RE: VIEWGRAPHS USED BY COMPLIANCE AT AUGUST
ACRS MEETING

REVIEW
OF
PIPING SYSTEMS STRESSES
AND
INSTALLATION

Enclosure 1

FIG. NO. 1M

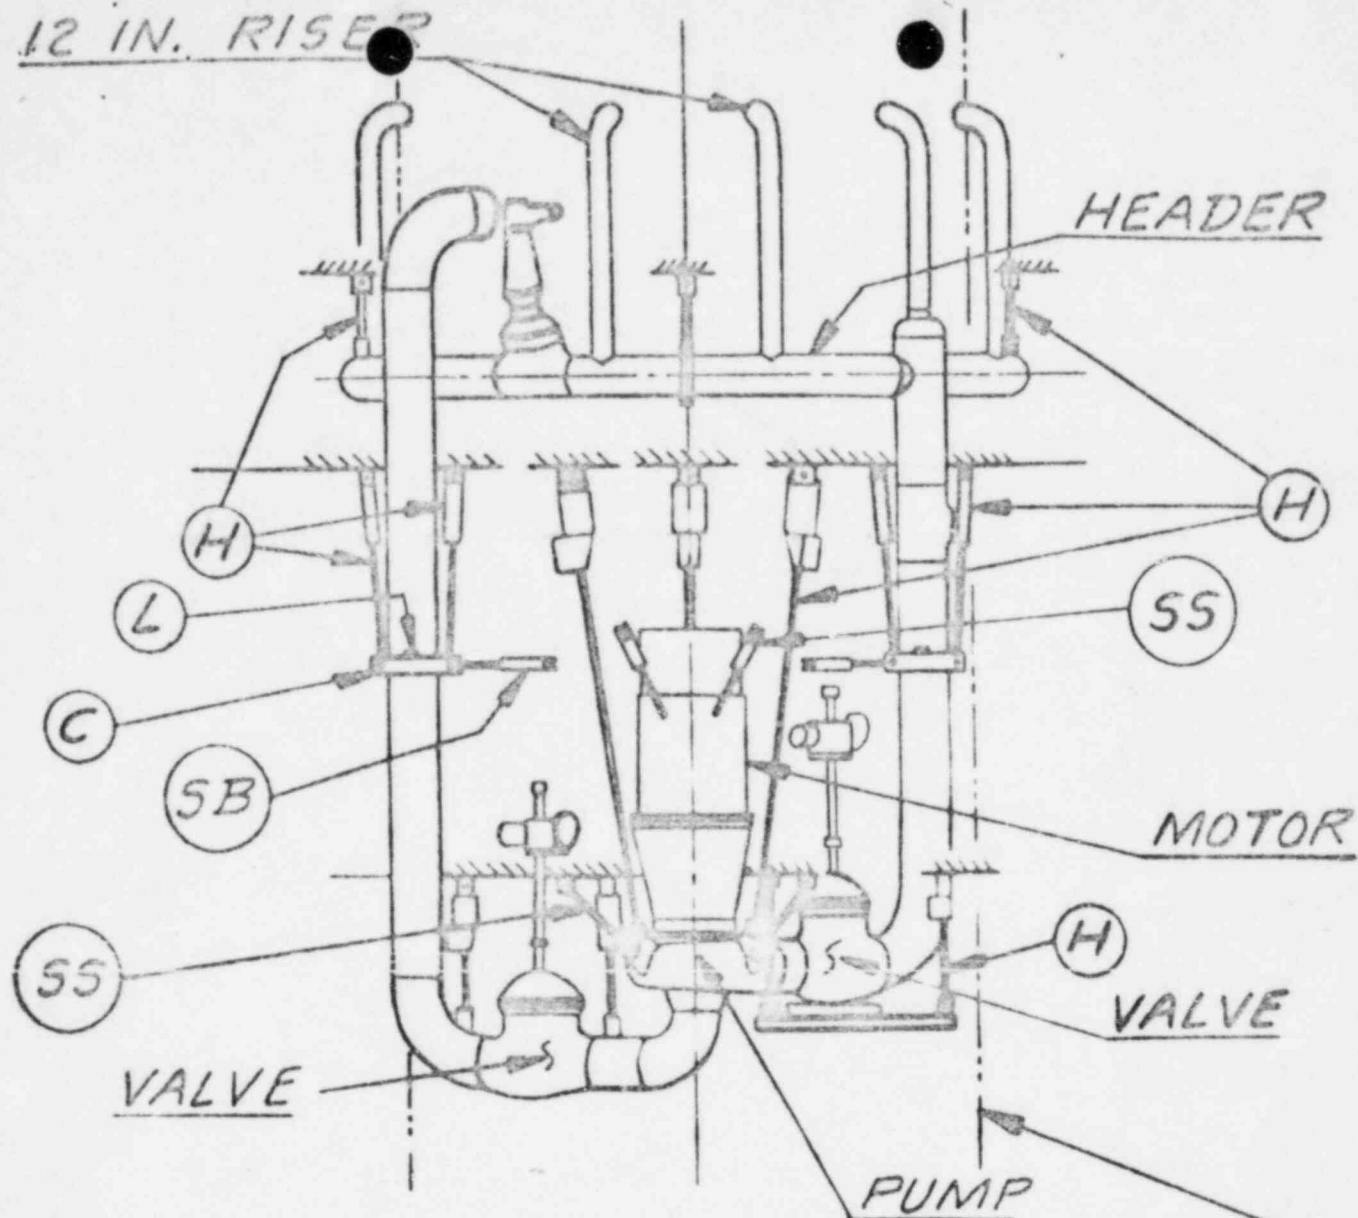
POINTS OF MAXIMUM STRESS

RECIRC LOOP

TABLE NO. 1M

(1) PRESSURE + WEIGHT LOADING

POINTS 50 & 147

AT 12 IN. NOZZLE NEAREST
EQUALIZING VALVE

CALCULATED STRESS 7736 PSI

ALLOWABLE STRESS 14400 PSI

(2) THERMAL EXPANSION LOADING

POINT 56

AT TEE BELOW 4 INCH
BYPASS VALVE

CALC. STRESS 23750 PSI

ALLOW. STRESS 27037 PSI

FIG. NO. 1R

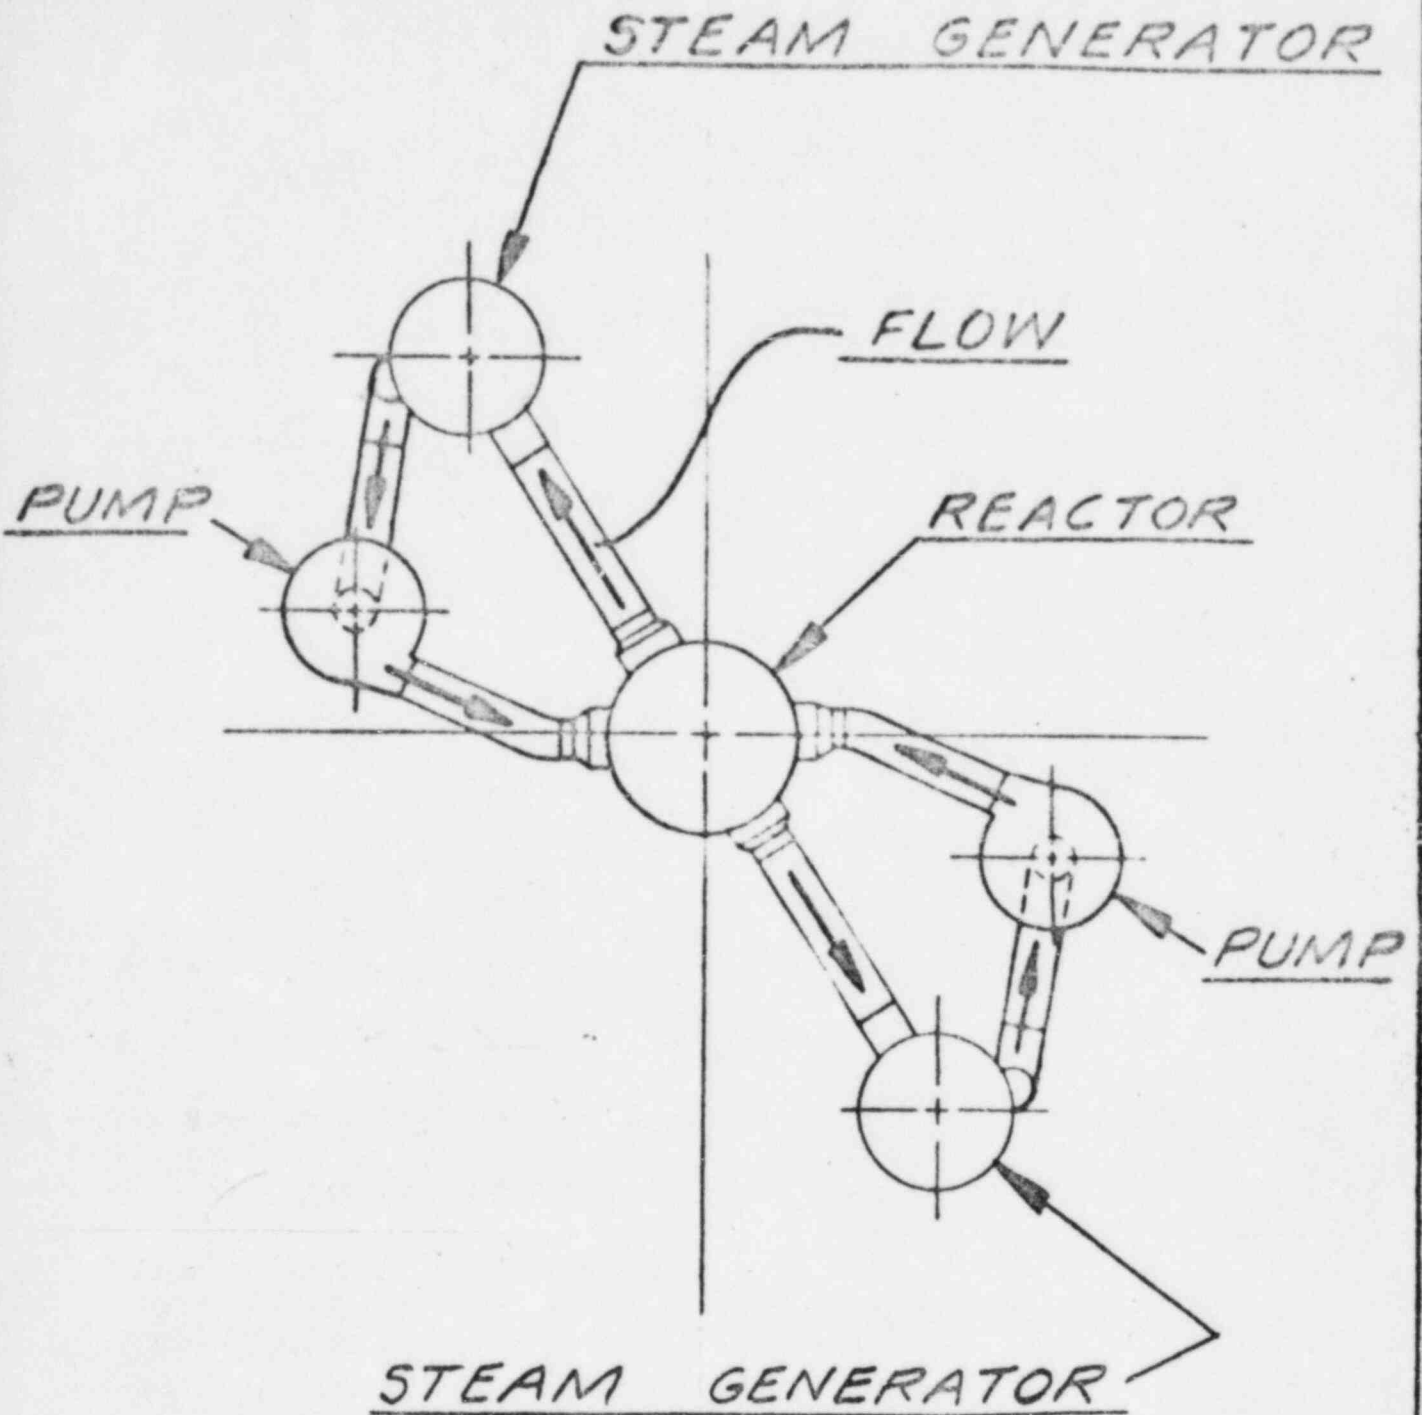
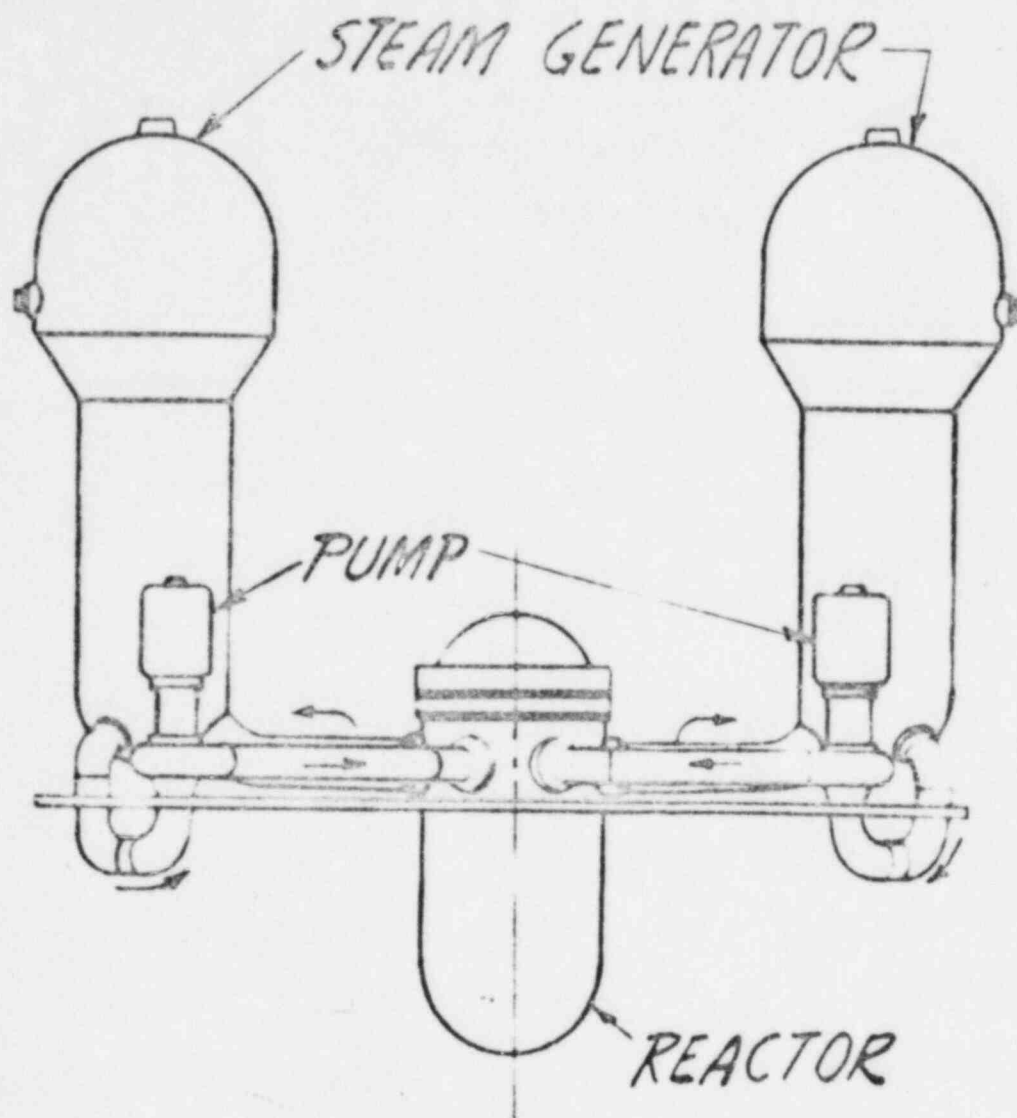
POINTS OF MAXIMUM STRESS
EXCLUDING PRIMARY LOOPS
TABLE NO. 1R

LOCATION	EXPANSION STRESS, PSI	
	CALCULATED	ALLOWABLE
26 MS-1-18	11715	20625
26 MS-2-43	6088	↓
26 MS-3-65	6472	↓
16 FW-9-2	15948	22500
16 FW-10-43	13609	↓
16 FW-11-79	11992	↓
12 RC-10-1	12463	27440
3 RC-32-18	5590	27850
4 RC-28-161	6951	27440
4 RC-29- ↓	↓	↓
4 RC-30- ↓	↓	↓
12 RC-11-31	22424	22500
4 RC-12- ↓	↓	↓
4 RC-13- ↓	↓	↓
4 RC-14- ↓	↓	↓
LINE NO.	SIGNIFIES SAME POINT	
3R

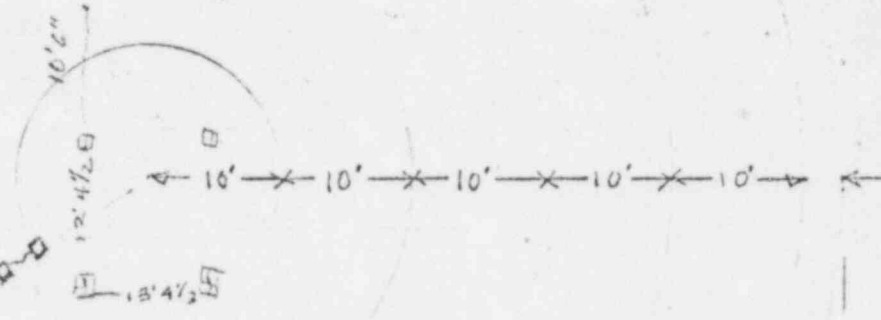
BUTT #10

JOINT HAS OIL LEAK

CRACK'S OIL LEAK

4" x 4" x 6" DEEP BLOCK OUT FOR BLEED VALVES THESE HAVE CONNECTING CRACKS

BUTT #4
H2O LEAK

OIL LEAK AT POOR JOINT

OIL LEAK AT #8 VERT DOWEL

#8 DOWEL OIL LEAK

Readings - Underside #3 Centerline Dome.

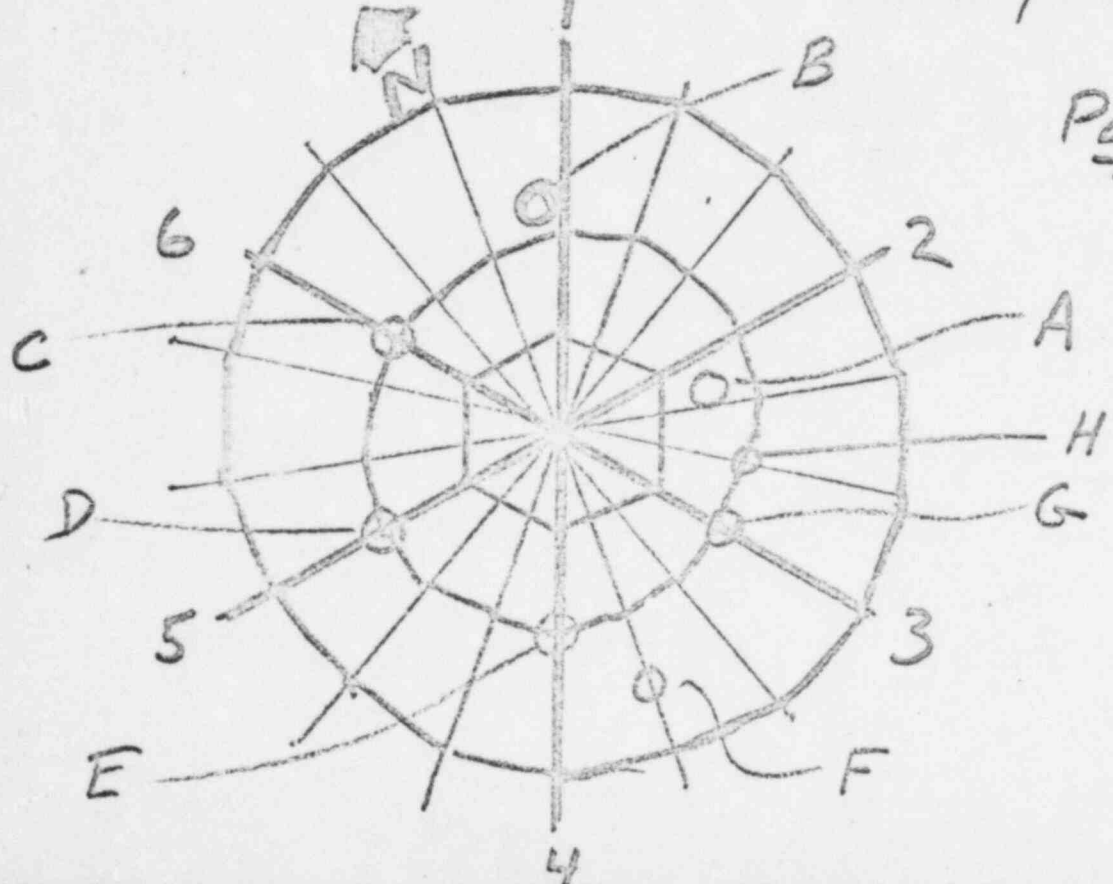
Suspicious Areas Based Upon Hammer Soundings

- A #2 Main Truss Beyond Cap Plate
- B 20' Out From Σ (4 sq. ft) just W. of # Main Truss
- C #6 Main Truss (NNW) 2nd Purline from Center.
- D #5 Main Truss - 2nd Purline From Center
- E #4 Main Truss, 2nd Purline Out.
- F Between #3 & #4 Main Trusses at 2nd Intermediate Truss - 2nd Purline Out.
- G #3 Main Truss - 2nd Purline Out
- H #2 Intermediate Truss Between #2 & #3 Main Trusses at 2nd Purline from Center.
